**STATE OF HAWAI'I
DEPARTMENT OF LAND AND NATURAL RESOURCES
OFFICE OF CONSERVATION AND COASTAL LANDS
Honolulu, Hawai'i**

April 25, 2014

REGARDING: Conservation District Use Application (CDUA-MA3663) for Shore Protection

BY: Hololani Resort Condominiums
4401 Lower Honoapi'ilani Road
Lahaina, Hawai'i 96761

Diagram A. Depicting the typical process of beach narrowing and loss fronting coastal armoring installed on an eroding beach.

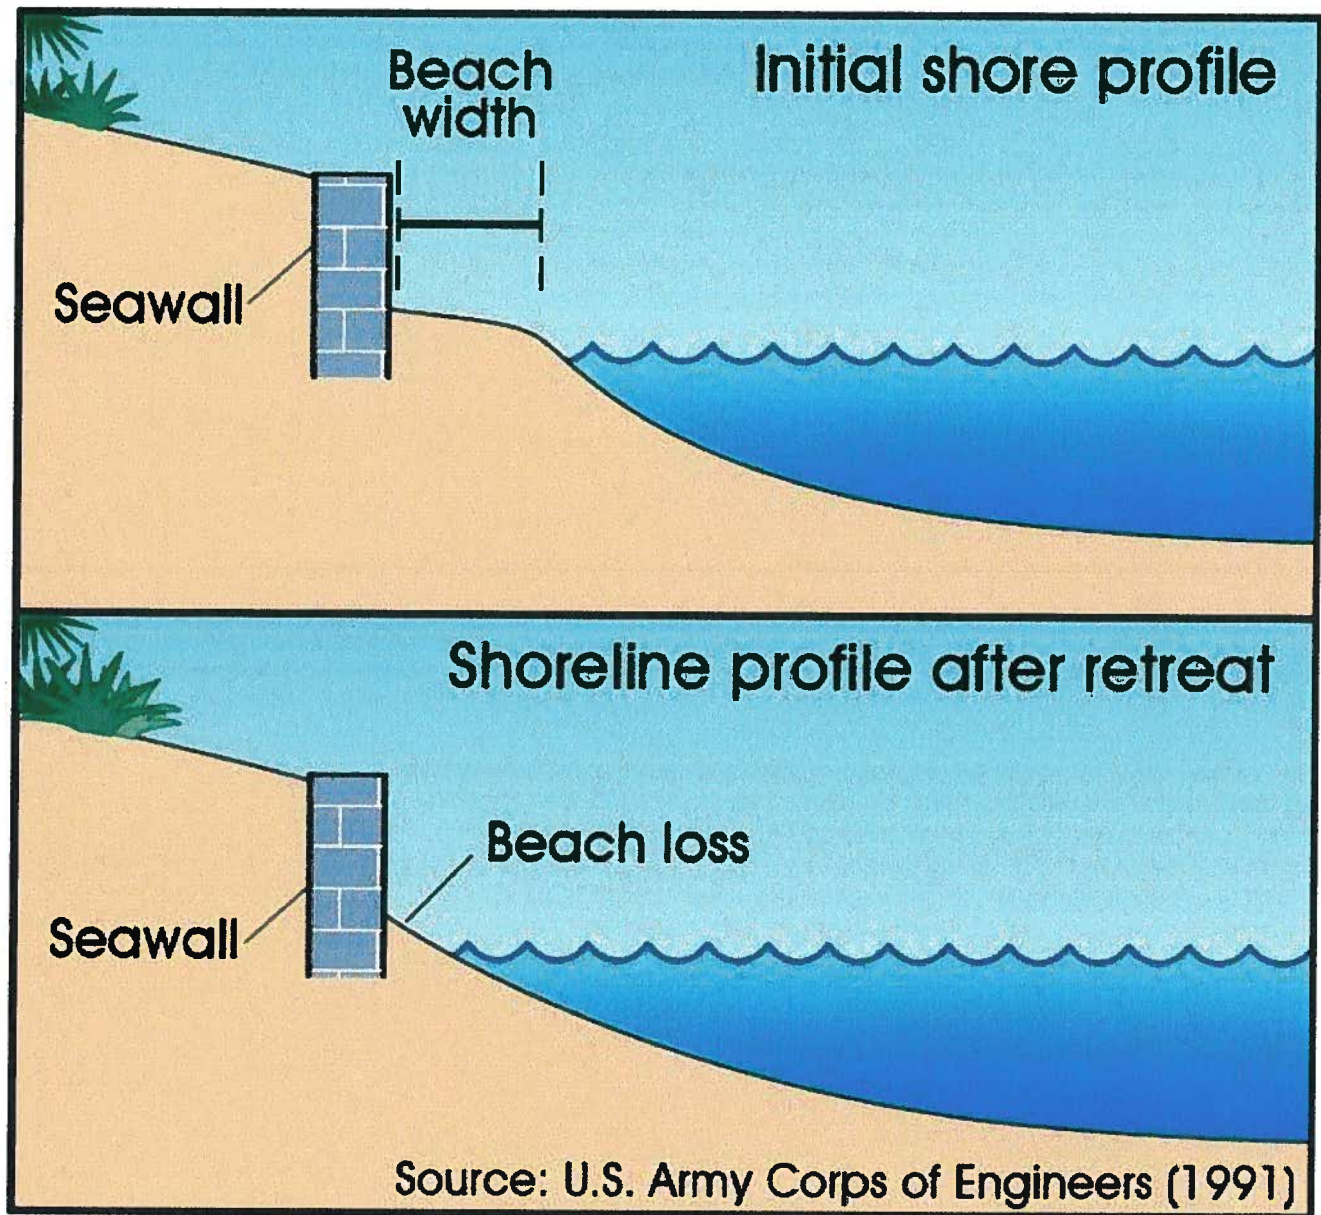
As depicted in Diagram A, a seawall or revetment can impound upland sand (e.g., dune) resources that would otherwise be available to nourish a retreating beach, increasing the rate of beach narrowing and loss fronting the structure⁶.

Diagram B. Installation of coastal armoring is typically a tradeoff between protecting private lands (left) or conserving public beach resources (right). Coastal armoring can also increase erosion at adjoining, unarmored beach through a process known as “flanking” or “end effects.”

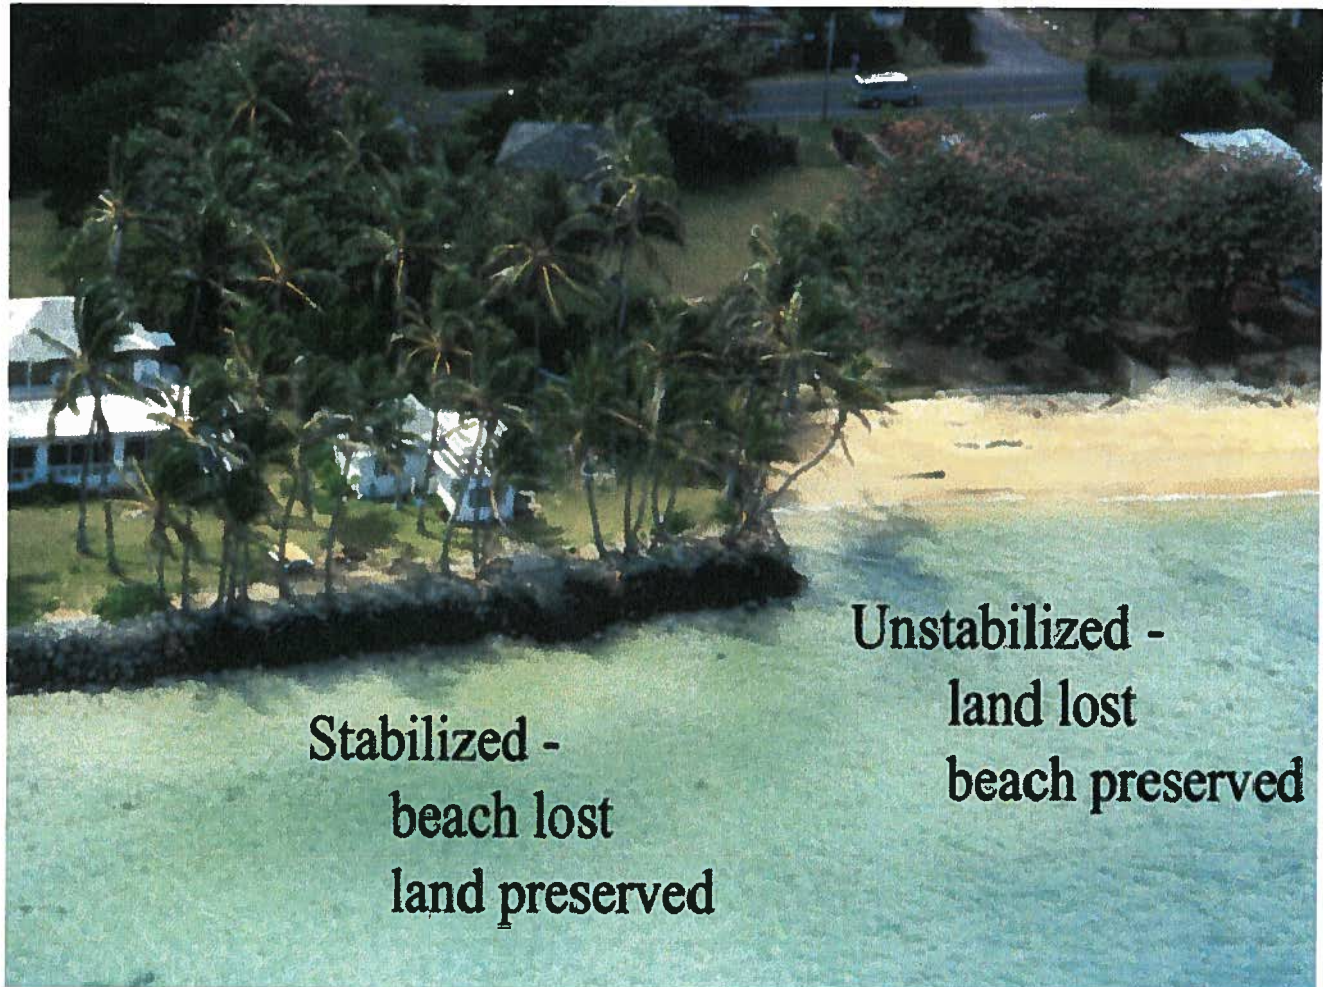
The impacts from existing coastal armoring on Kahana Beach are clear, particularly fronting the Pohailani Condominium adjacent to the HRC. Following a common pattern observed throughout Hawaii on eroding beaches, a revetment was installed at the Pohailani in response to a natural trend of shoreline erosion in an effort to protect the landward development. The revetment fixed the backshore position while the water line continued to retreat landward, resulting in beach narrowing and eventually total loss of the beach fronting the Pohailani (**Diagram A**). The Pohailani revetment now blocks sand transport between the previously adjoined beach to the north and is also likely contributing to increased erosion to the HRC property through “flanking” or “end effects” as wave and current energy is directed around the end of the structure (**Diagram B**). This typical pattern, resulting in progressive need for alongshore shoreline protection, is often described as a “zipper” or “domino” effect whereby installation of coastal armoring on one property ultimately increases the need for

shoreline protection on adjacent properties as erosion increases due to flanking and impoundment of sand resources. Beach loss and seawall construction at Lanikai, east Oahu, is a commonly cited example of this domino effect.

If armoring is installed fronting the HRC, it may be just a matter of time before permanent shore protection will be requested by the abutting Royal Kahana Condominium – the next property down-drift (See **Exhibit 2**). In fact, temporary shoreline protection (rock mattresses) has already been installed fronting the Royal Kahana in response to increased erosion.

EXHIBIT 11

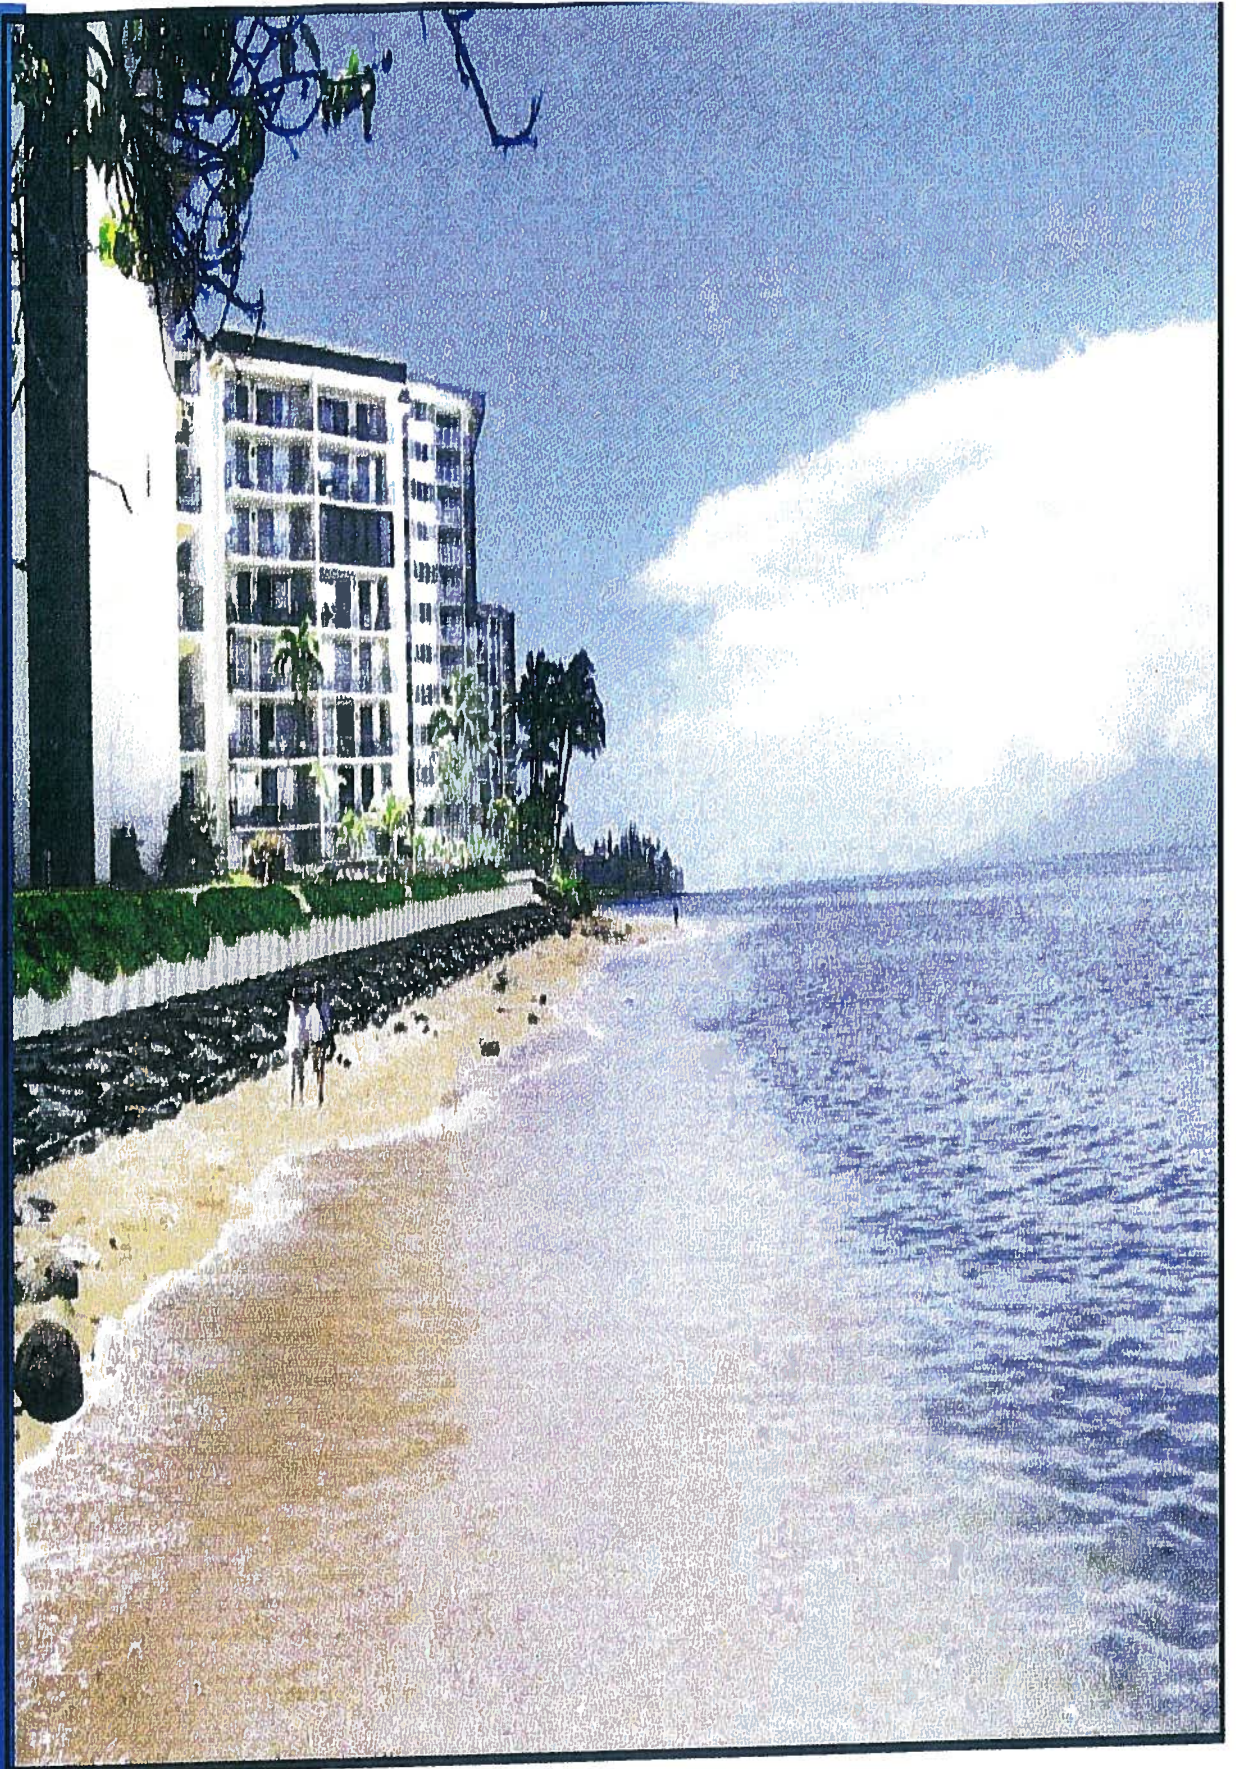
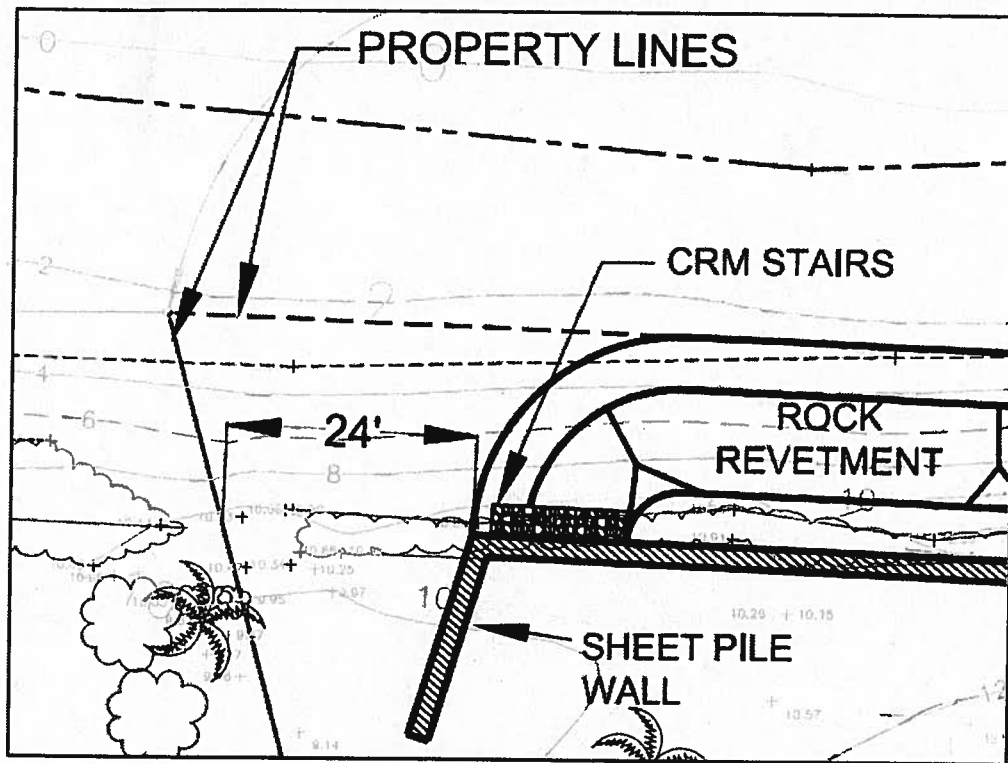
Staff would like to clarify that we believe the proposed hybrid revetment design will “not” promote seasonal sand accretion as stated repeatedly by the applicant’s consultant⁸. Any coastal hardening structure in this location is likely to accelerate beach loss and flanking effects⁹. Revetments do not “accrete sand” on chronically eroding beaches. While sand may continue to appear ephemerally from season to season (even with the structure in place), the long term trend for the beach appears to be erosion (sand loss and beach narrowing). The most likely scenario is that the size and duration of the seasonally-appearing beach will continually decline over years to decades fronting the proposed structure until the beach is lost year-round.

While the effects of the structure are not thought to rise to the level of “significant impacts”, it may hasten the seasonal and long-term beach loss in front of the Hololani. The structure may also affect the neighboring Royal Kahana property. The effects attributable to the structure may be addressed with design modifications and some limited sand placement (nourishment).

3. The Applicant shall include both lateral and vertical public access to the shoreline fronting Hololani.
4. A design modification should be considered, whereby the revetment portion of the structure is buried deeper than proposed in order to mitigate the eventual exposure of the revetment's toe with continued erosion. In figure 6 on page 10 of the CDDA, the current design for the revetment portion of the structure buries the revetment toe at only 0.5 feet below low water. With continued sand deflation and sand loss in front of the structure, there is a concern that the eventual exposure and possible undermining of the revetment toe will compromise the energy absorbing function of the revetment.

4. The Department requests a design modification to place the toe of the structure at greater depth, with the concern that the toe may become exposed and undermined.

From FEA: Figure 4-21. Schematic of foundation conditions (note: B1 is at the north end of the property)

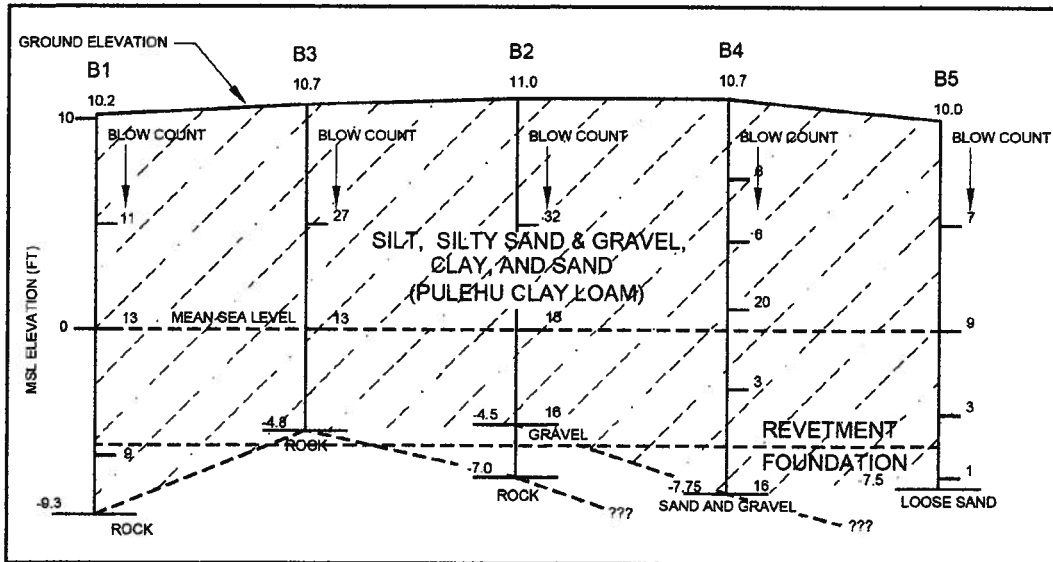
This comment is subdivided into six sections, 5a through 5f. Comments 5a through 5c are concerned with the nature of the soils at the project site. The Department writes that the substrate is primarily described as “clay” in the DEA, and mostly described as silt, sandy silt, and gravel in the project geotechnical report. The Department is referred to the footnote on page 1 of the FEA:

The turbidity released by the erosion of the substrate is well-documented by Figure 1-3 in the FEA. The vertical nature of the shoreline escarpment and the overall morphology of the site, as well as the geology, are as described in the FEA (see Sections 4.1.5, 4.1.6, and 4.1.11). The figure below (Figure 4-21 in the FEA) is a summary of substrate conditions as presented in the FEA:

Figure 2. Accreted beach, February, 2014

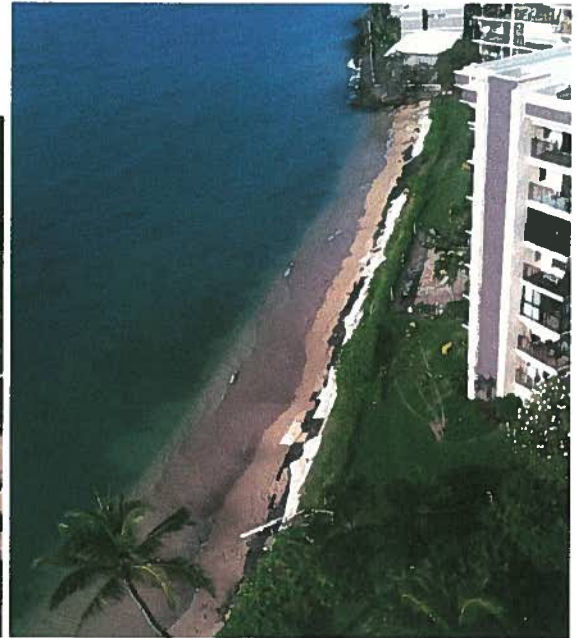
In Comment 11, the Department notes:

Figure 1 is from the FEA, and shows the shoreline near the Hololani/Royal Kahana property line in 2006, before construction of the temporary shore protection. Figure 2 was taken on February 10, 2014. Figure 1 shows the site nearly devoid of sand. Figure 2 shows the entire Hololani reach with a high volume of sand, with the beach toe aligned with the Pohailani seawall. Additional beach accretion would require migration and stabilization of sand north of the Pohailani. As detailed in FEA (see Section 4.1.11), the cycles of accretion and deflation are regular seasonal events at the Hololani. The effects of the existing temporary

protection are minimal, and effects of the preferred alternative should be similar.
